**MODIFICATION REQUEST:
Global Switch Sydney 2 Data Centre
273 Pyrmont Street, Ultimo**

MP 08_0222 MOD 3

**Minor amendments to approved building design
and construction staging**

Director General's
Environmental Assessment Report
Section 75W of the
Environmental Planning and Assessment Act 1979

Figure 2a: Extract from site plan showing the location of the Western Distributor at the northern end of the site (Source: dem)

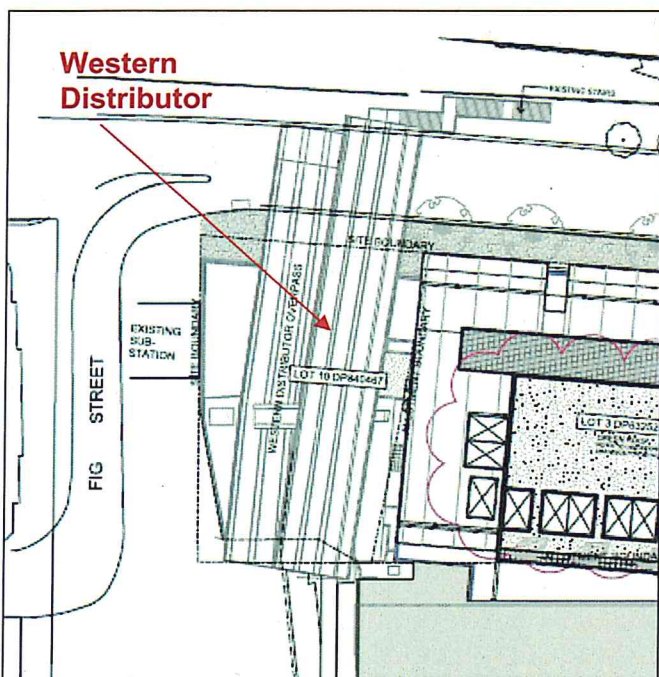
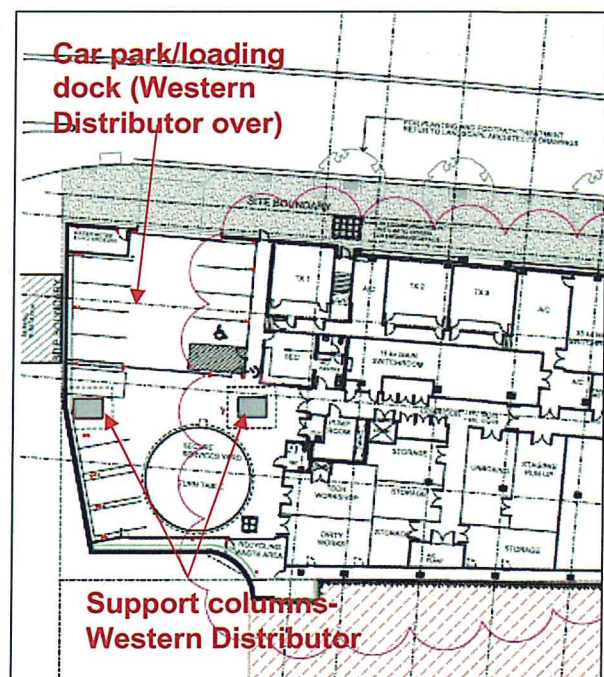
In relation to MOD 3, the RMS initially raised safety concerns in relation to the proximity of excavation associated with construction of the development on the structural integrity and serviceability of the Western Distributor bridge piers. In addition, the RMS advised that the development and more specifically, the roof over the car park and loading dock area at the northern end of the site, may prevent future access and maintenance. The location of the western distributor relative to the work is shown in **Figures 2a** and **2b** below.

In response, the proponent clarified that the extent of works to the existing data storage facility affected by the RMS requirements are confined to the proposed northern extension of the ground floor and roof over the car park (first floor level), in proximity to the structural supports for the western distributor. In addition, the proponent advised that while it may be possible to accommodate the RMS requirements, they are onerous, involve cost, risks and may include penalties received from the Principal Contractor for any programme delay.

Subsequent meetings have been convened between the department, the proponent and the RMS to resolve this matter. The department notes that the access and maintenance requirements of the RMS have not been identified in any prior comments provided by the RMS in relation to this project application. Despite the RMS initially advising that the working load of the roof structure would be required to be redesigned and strengthened to be not less than 2.5 kN/m² (noting that the current approved design is 1kN/m²) and furthermore, that visual inspections and maintenance work would

need to be undertaken entirely from the surface of the roof (thereby, necessitating the need for the roof to support increased loading to 2.5 kN/m²), the RMS has recently advised of the following:

- Its preference to enter into a formal agreement with the owner to ensure future access is available for routine inspection purposes rather than pursue changes to existing development consent for upgrading the roof as an RMS work platform;
- that it is possible for future maintenance activities to be undertaken from a suspended work platform, as required; and
- that the support columns contained within the new building footprint will also be subject to an access agreement.

Figure 3: East elevation (Source: dem)

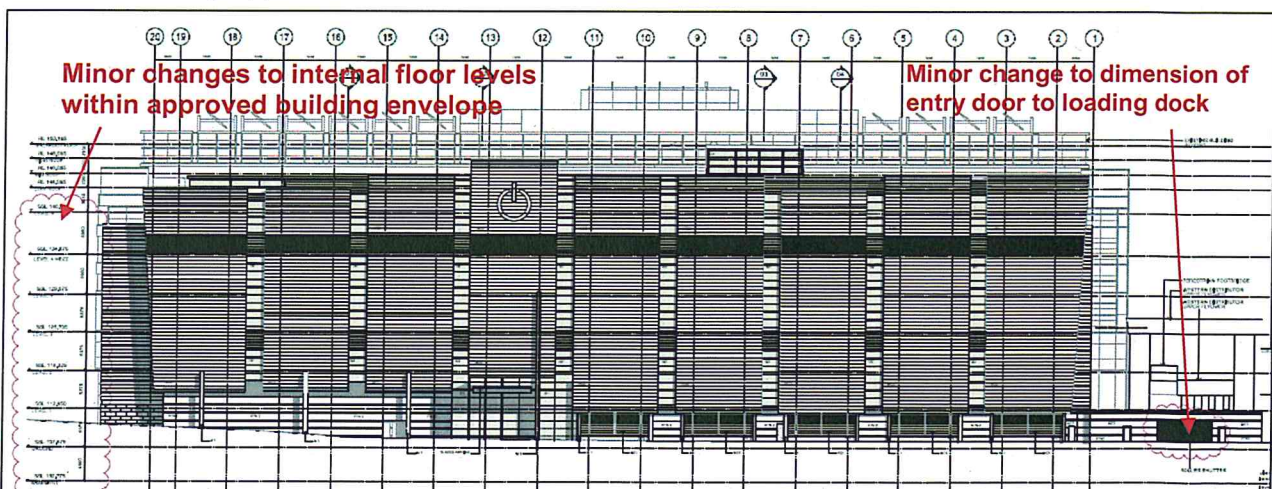
As illustrated in **Figure 3** below, the proposal also includes an increase to the dimension of the roller shutter door providing access to the loading dock area. The department raises no objection to this amendment given it will aid access to the loading dock and its location remains consistent with that already approved.

Having regard to the above, the department is satisfied that the design changes will not result in any adverse environmental impacts, and therefore, recommends that the amendments be approved.

Figure 4: Proposed construction and progressive occupation stages (source: dem)

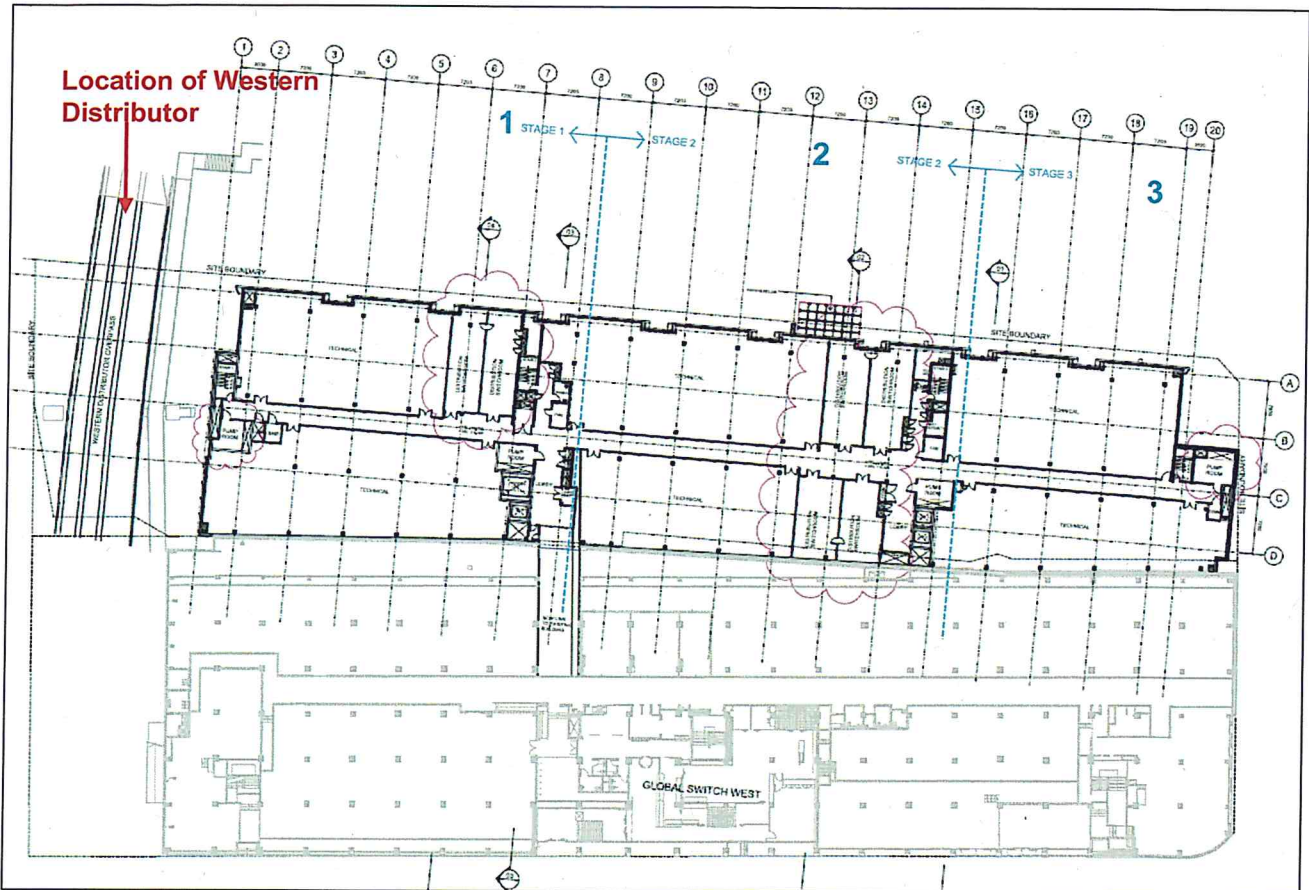
MOD 2 approved the construction of the development in two (2) stages allowing for the progression occupation of the building on completion. The current modification application proposes to further adjust the construction program to allow for three (3) stages as illustrated in **Figure 4**. As with MOD 2, MOD 3 will allow for the building to be progressively constructed from northern end of the site. Final details of the main building stages and progressive internal fitout and occupation of the building are to be provided to the PCA for approval prior to the release of the relevant Construction Certificate.

The department has considered the proposed construction stages (refer **Figure 4**) relative to the internal layout and function of the building and raises no objection to the proposal. It is noted that Stage 1 includes the completion of the load dock and parking area at the northern end of the site. This is considered appropriate for the ongoing functioning of the building through to construction completion and will also ensure that traffic impacts associated with occupation can be contained on-site.

In conjunction with the staged construction of the building, it is proposed to stage the payment of the section 94 Contributions to reflect the development stage. The extent of the proposed Stage 1 works roughly accords with the extent of Stage 1 works approved in MOD 2. In the determination of MOD 2, Condition B1 was amended to require 50% of the contributions to be paid at Stage 1 with the remaining 50% to be paid at Stage 2. On this basis, the department raises no objection to the proposed timing for the payment of the contribution recommended by the proponent, with the contributions being paid in stages as follows:

- 50% payment prior to the issues of the Stage 1 Construction Certificate;
- 25% payment prior to the issue of the Stage 2 Construction Certificate; and
- 25% payment prior to the issue of the Stage 3 Construction Certificate.
